## HORSHAM DISTRICT COUNCIL CONSULTATION

<b>TO:</b>	Horsham District Council – Planning Dept
<b>LOCATION:</b>	Land To The South of Furners Lane Henfield West Sussex
<b>DESCRIPTION:</b>	Erection of 29 dwellings with associated landscaping, open space, parking and creation of new vehicular access
<b>REFERENCE:</b>	DC/24/1538
<b>RECOMMENDATION:</b>	Advice / More Information / Modification

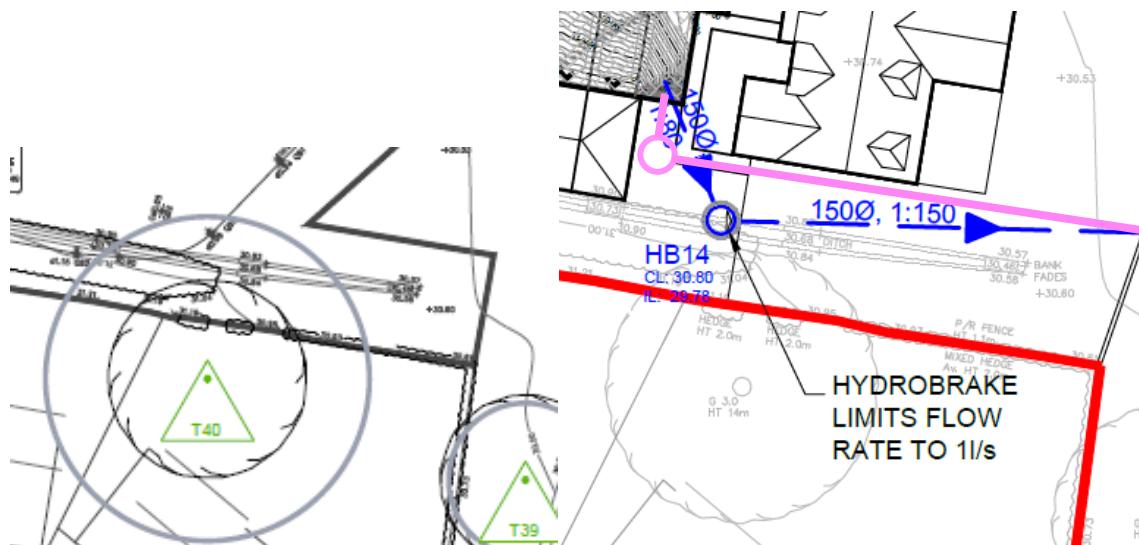
2. Clarification is requested in regard to surfacing for the PRoW – the landscape masterplan currently suggests amenity grass. Please provide a hard landscape plan indicating details of proposed surfacing throughout the scheme.
3. Please amend the remaining boundary of plot 9 to brick wall as it is visible and abutting the public realm (highlighted in yellow, below).
